B. PUBLIC AGENDA ITEMS

TO: Planning and Zoning Commission
FROM: Evann Martin, Assistant Planner
DATE: January 4, 2022
RE: Destination Market Plat 7 – Final Plat

RE: Jordison Construction Site Plan

The Development Services Department is in receipt of a proposed Site Plan for Jordison Construction. Based on the review of the provided submittal materials, staff have the following comments:

SHEET NUMBER:
C6.1

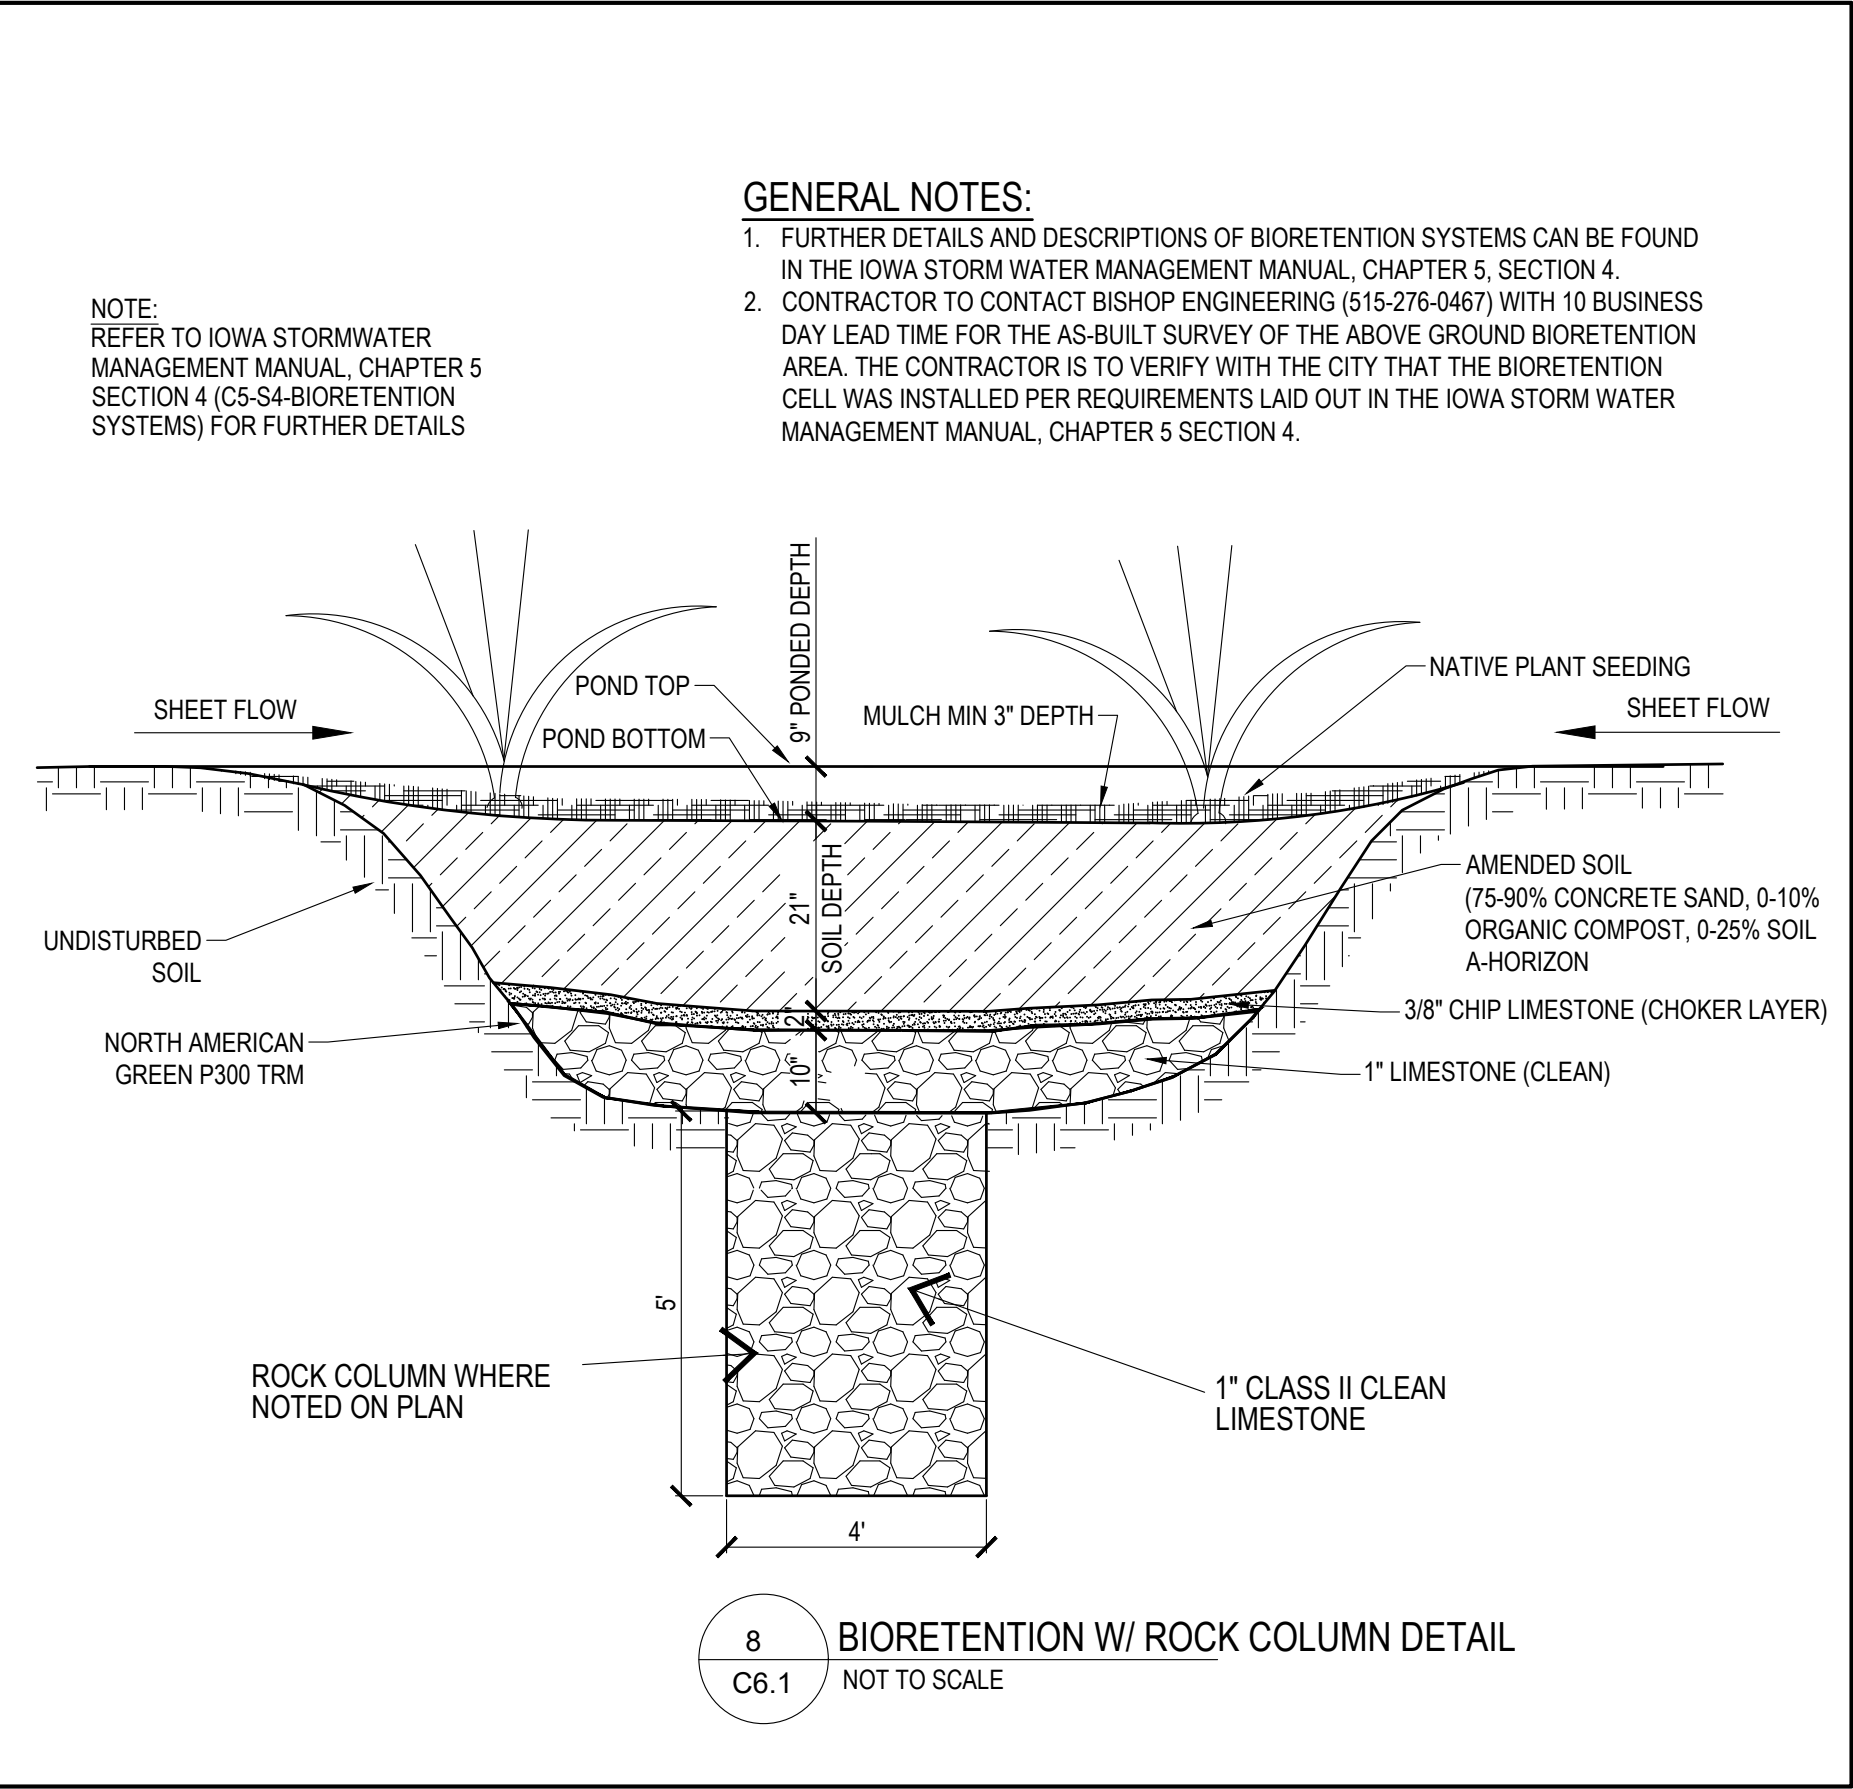
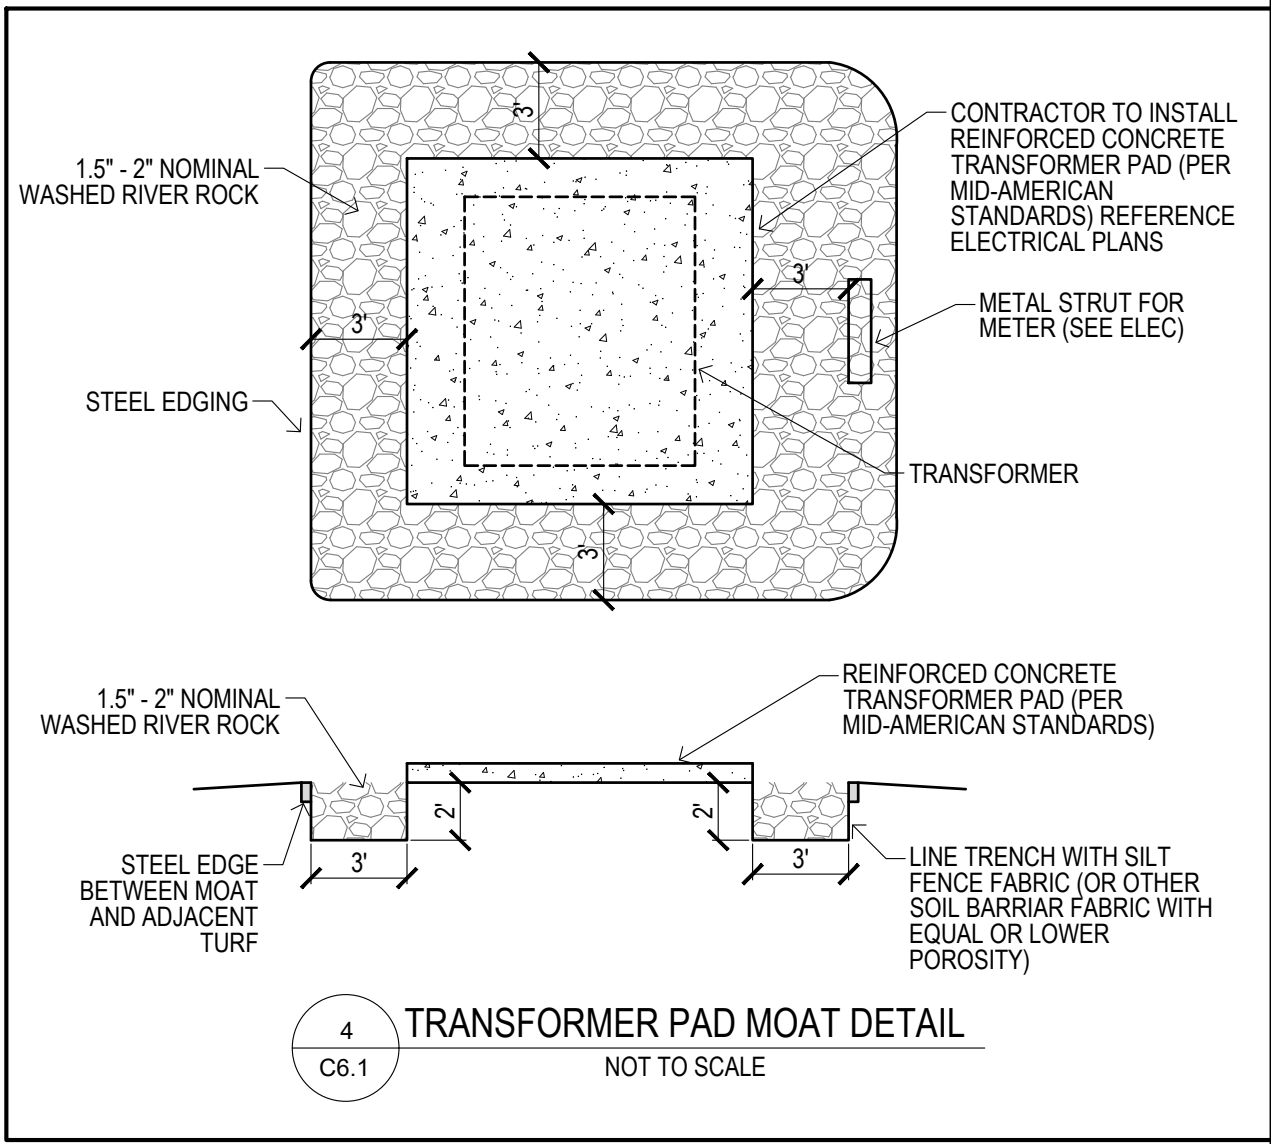
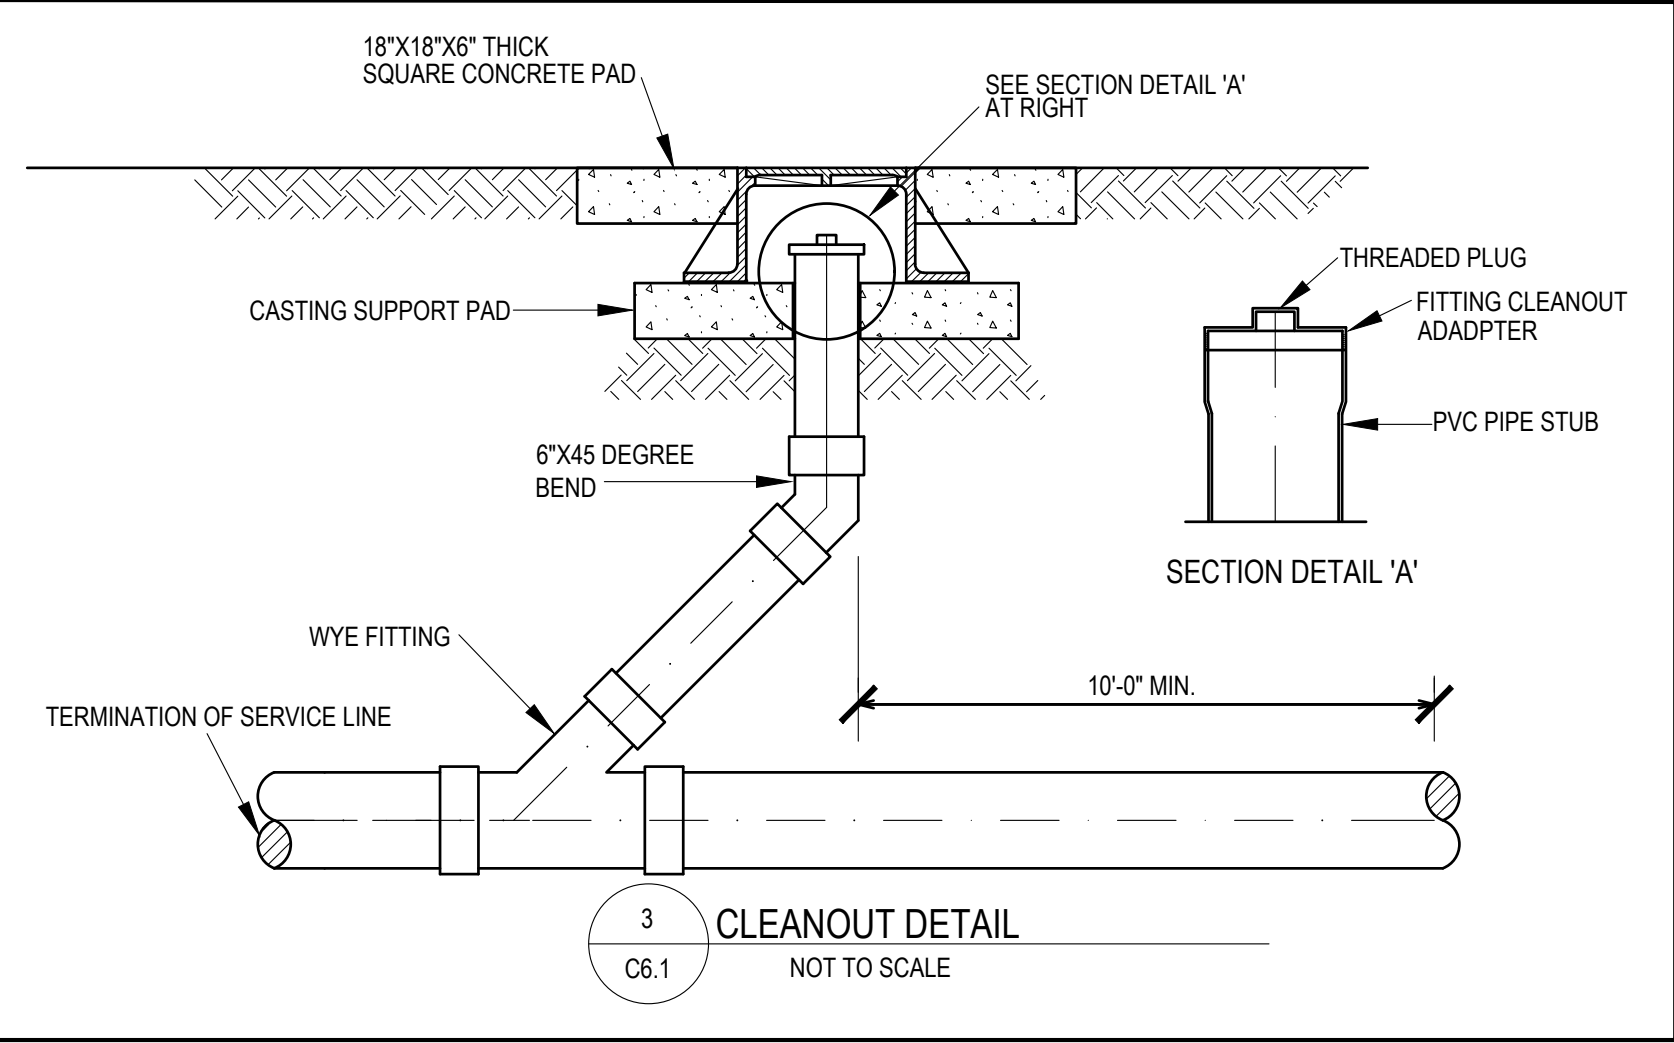
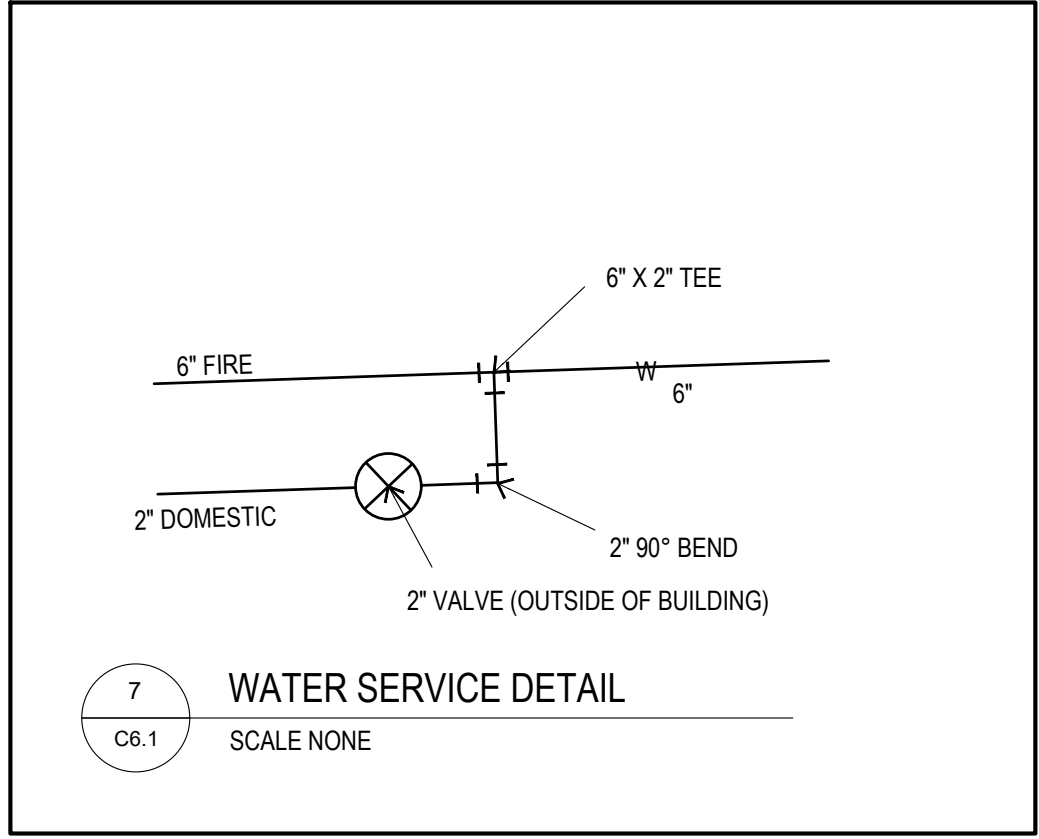
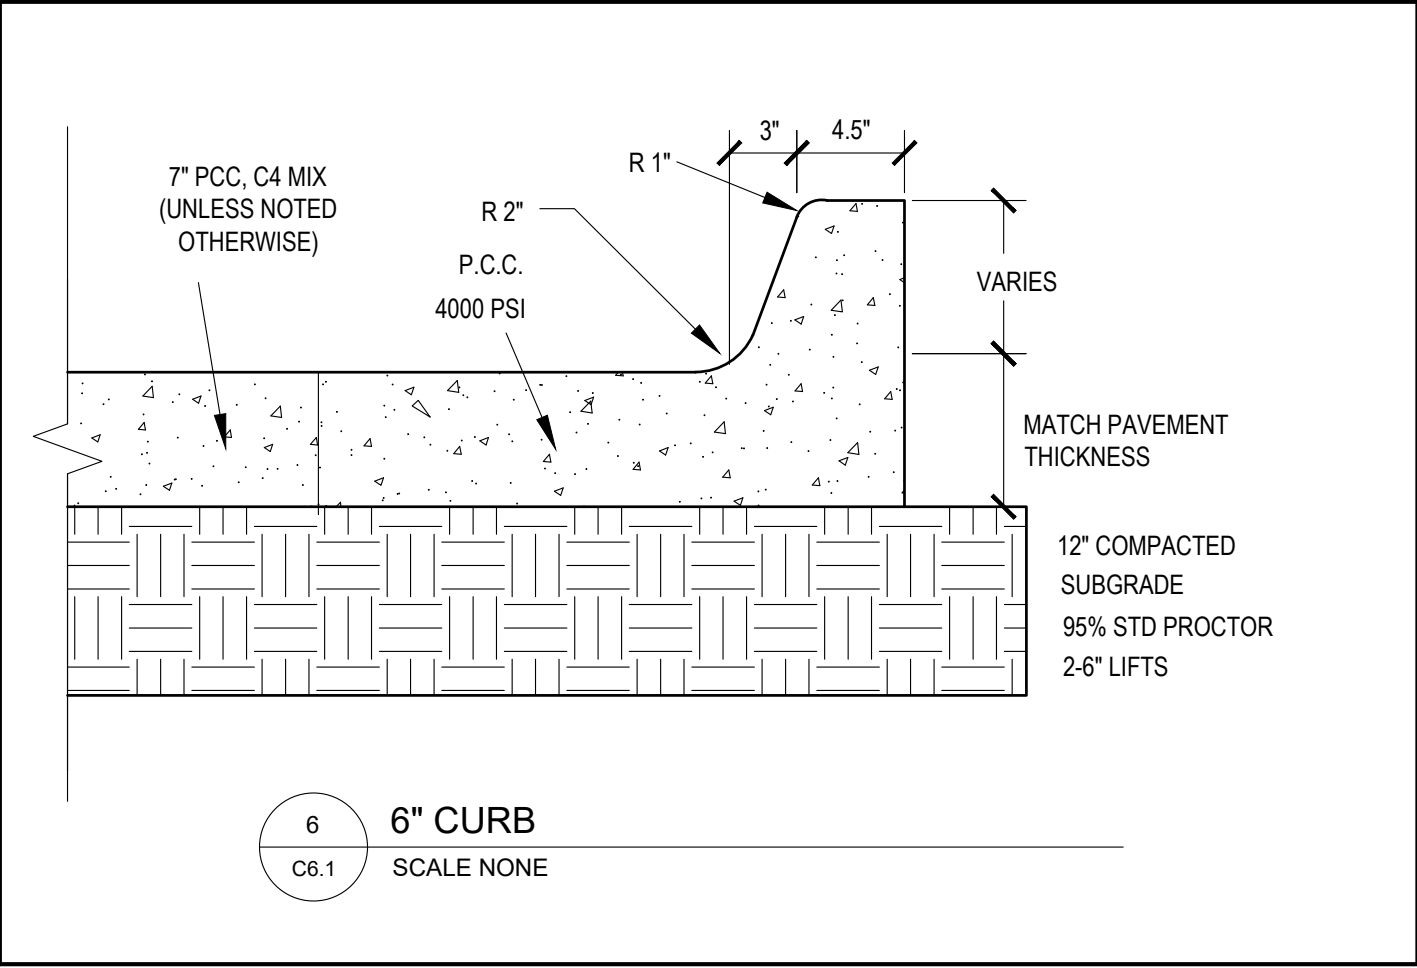
~~1. Structure #6 on the plan is an FES. Please revise label.~~

~~2. On the water service detail, denote that the 2" valve will be on the outside of the building.~~

3. Water service detail to show valve on fire line also.

4. Provide flume detail.

1. Sheet C3.1 or C5.1: Show modified soil area.
2. Sheet C3.1: Any erosion control or energy dissipation needed at the curb cuts?
3. Sheet C6.1, Detail 8: Show mulch layer as a minimum of 3".
